Request for Class II Permissive Change(C2PC)

FCC ID: VG8TM034DYY

This is a C2PC application for which the previous grant was issued on 2025-8-27.

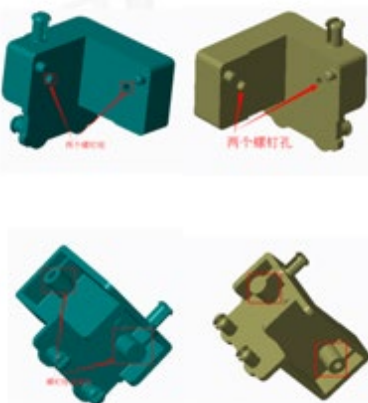
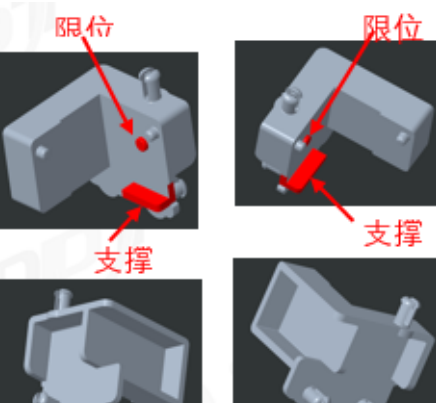
No.:	Original	New	Difference(s)
1	 Model No.: MD-102AMR-5	 Model No.: MD-102AMS-1	High-voltage transformer: - Difference only for model number, the new high-voltage transformer is MD-102AMS-1, the original is MD-102AMR-5. - The magnetron and other circuit are exactly same as before.
			Roller brackets: remove screw posts, add limiting posts and supporting ribs.
